CITY OF CODY
PLANNING, ZONING AND ADJUSTMENT BOARD AGENDA
SPECIAL MEETING OF TUESDAY, DECEMBER 19, 2023 AT 12:00 P.M. (NOON)
CODY CITY HALL COUNCIL CHAMBERS, 1338 RUMSEY AVENUE, CODY, WY

MEETING DATE:	DECEMBER 19, 2023	TYPE OF ACTION NEEDED	
AGENDA ITEM:		P&Z BOARD APPROVAL:	X
SUBJECT:	PARKING PLAN REVIEW: 1922 BIG HORN AVENUE. SPR 2023-34	RECOMMENDATION TO COUNCIL:	
PREPARED BY:	TODD STOWELL, CITY PLANNER	DISCUSSION ONLY:

MEETING DATE:	DECEMBER 19, 2023	TYPE OF ACTION NEEDED	
AGENDA ITEM:		P&Z BOARD APPROVAL:	
SUBJECT:	FINAL PLAT FOR THE SOMMER MINOR SUBDIVISION—A 2-LOT SUBDIVISION. SUB 2023-03	RECOMMENDATION TO COUNCIL:	X
PREPARED BY:	TODD STOWELL, CITY PLANNER	DISCUSSION ONLY:

PLAT SHOWING - SOMMER MINOR SUBDIVISION

Parking plan

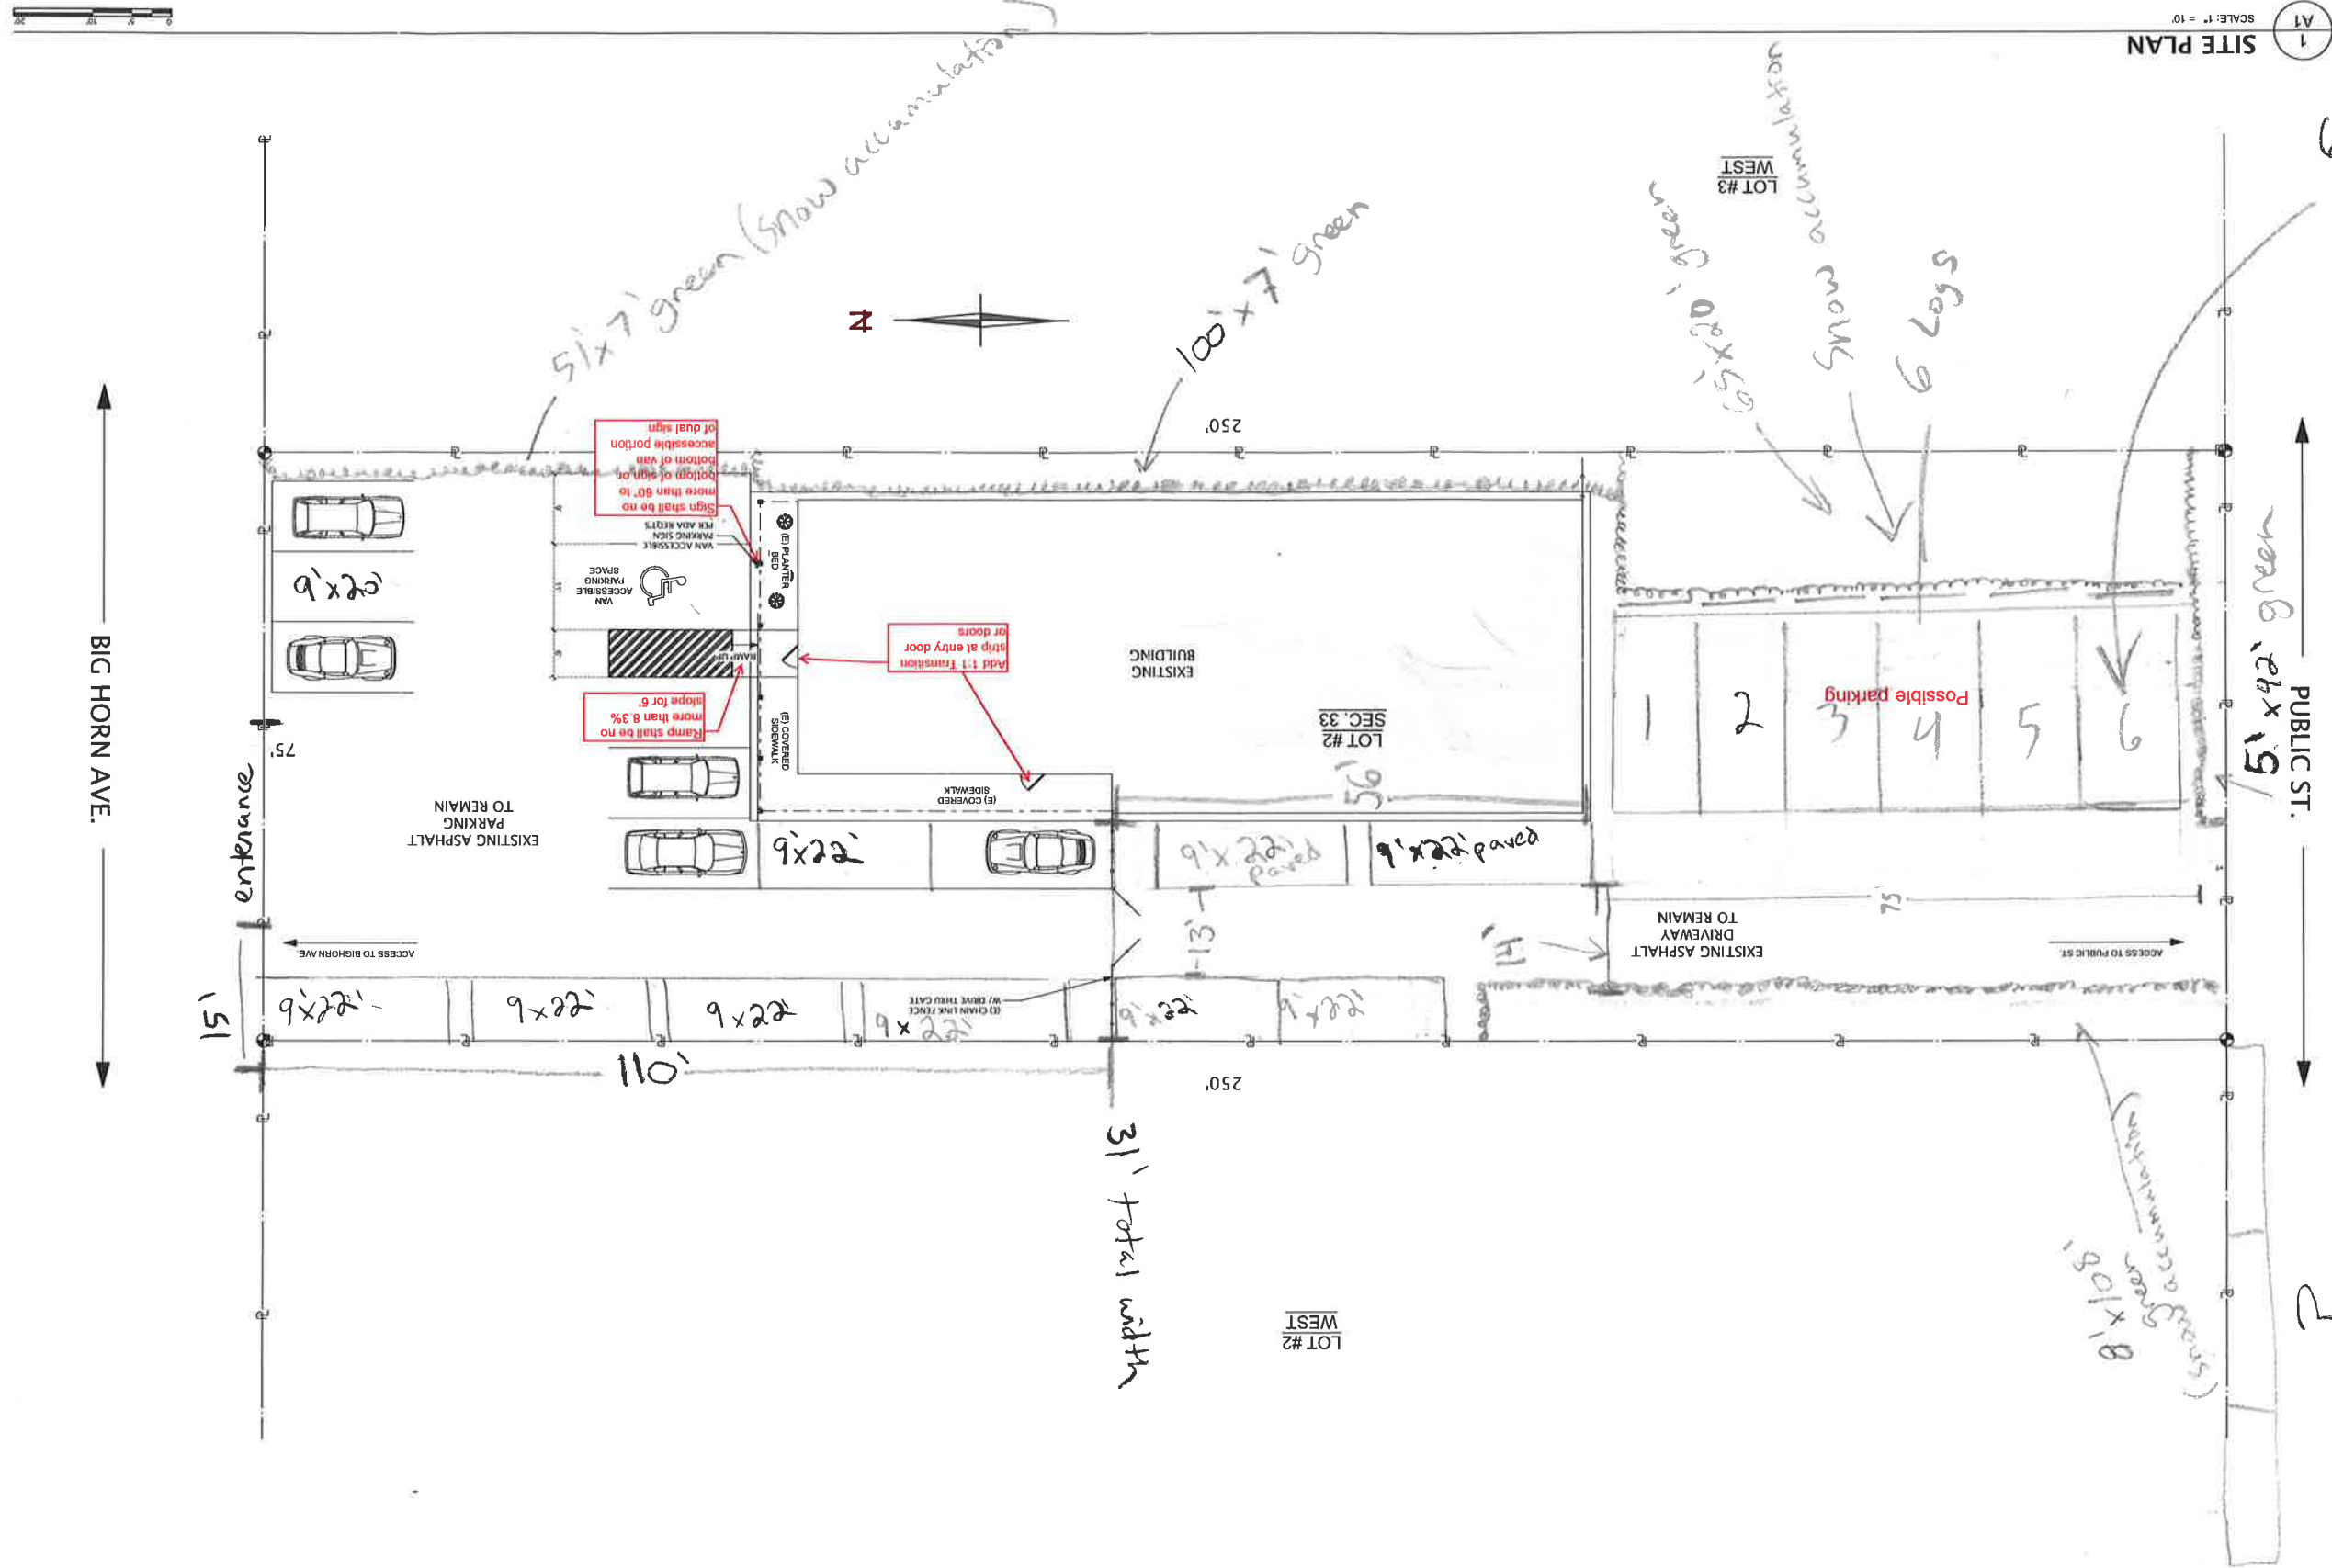
There are a few edits to the parking plan that are needed.

- a) The western parking space of the group of three shown next to Big Horn Avenue is in the driveway approach, which is dangerous. It should not be marked as a parking space.
- b) There is enough room to add a 7th space to the row to the south of the building, which should occur to make up for the "lost" space next to Big Horn Avenue.
- c) The northernmost parking space along the west property line should be held back from the Big horn Avenue sidewalk about five feet for sight distance purposes.

- d) If the fence located about midpoint of the building remains, there will only be room for one space south and west of the gate, unless vegetation is removed.
- e) The parking being added to the south of the building will need lighting, if the area will be used at night. There is a fixture on the back of the building that can be changed out with a compliant full cutoff fixture to provide the required lighting.

- 1) The parallel spaces along the west property line could be marked at 25' in length, which would be more convenient and accommodate larger vehicles. 25' spacing is used for the markings on main street.
- 2) The lighting of the front parking lot occurs from the under canopy lights and two halogen spotlights mounted on the front of the building. The halogen spotlights should be eliminated or replaced with full cutoff style fixtures to eliminate the current glare issue they create.

The required modifications to the parking plan include:

- a) Do not mark or use the western parking space of the group of three shown on the parking plan next to Big Horn Avenue, as it is in the driveway approach.

- b) Add a 7th space to the row of parking to the south of the building.
- c) Hold back the northernmost parking space along the west property line at least five feet from the Big horn Avenue sidewalk.

- d) If the fence located about midpoint of the building remains, there will only be room for one space south and west of the gate, unless vegetation is removed.

- e) The parking being added to the south of the building will need lighting, if that parking area will be used at night. There is a fixture on the back of the building that can be changed out with a compliant full cutoff fixture to provide the required lighting. Any replacement fixture is to be reviewed by the City planner to verify that it is full cutoff in style, no more than 4000K color temperature, and has an illumination pattern that best matches the situation (likely a forward throw pattern).

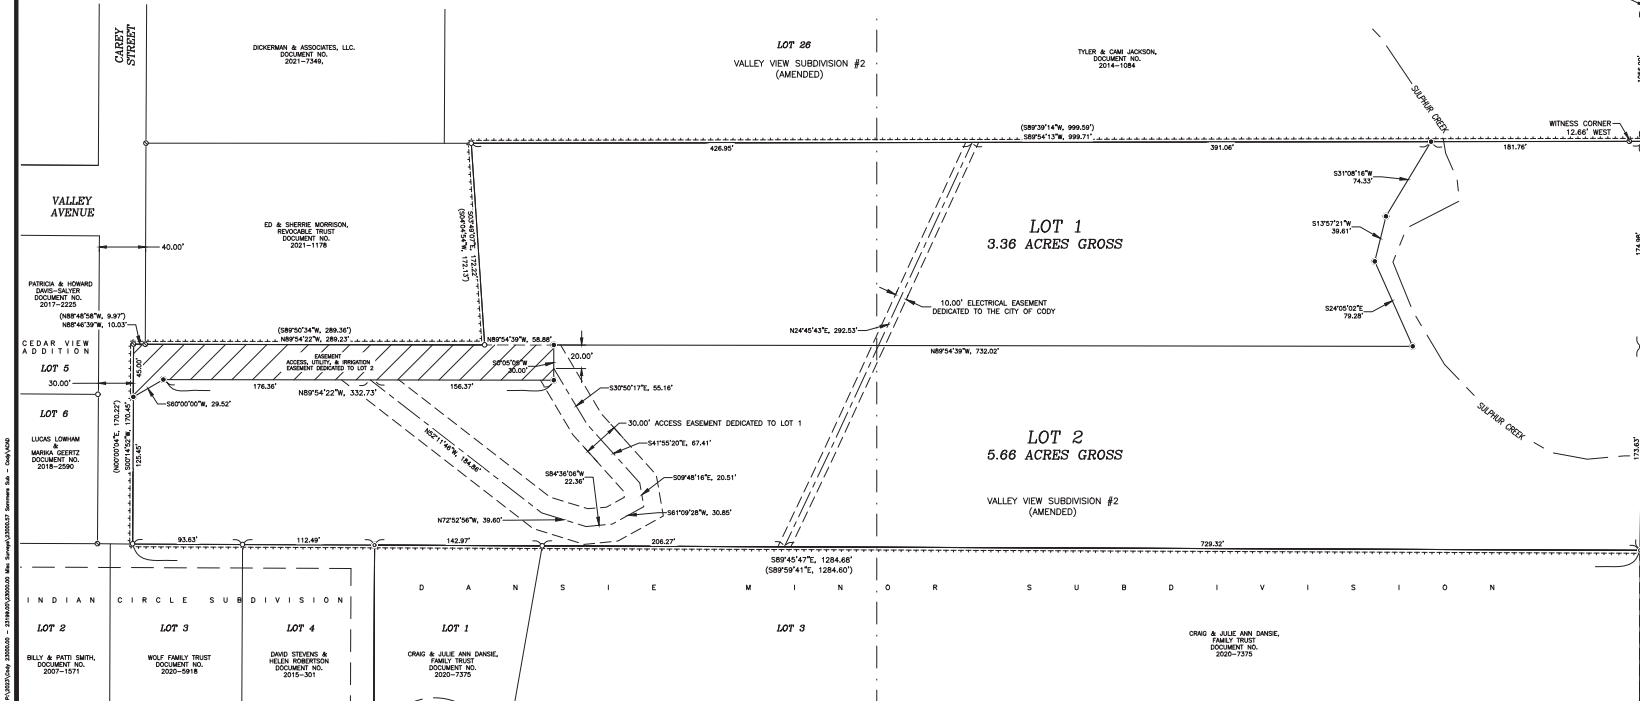
The final plat needs the following edits:

- a) With the change of ownership to a trust, verify the signatories.
- b) In the legend, remove the word "parcel" from "Easement parcel created his plat".

2. Prior to the mayor signing the final plat complete the edits to the final plat, including any change after verifying the signatories, and removing the word "parcel" from "Easement parcel created his plat" in the legend.
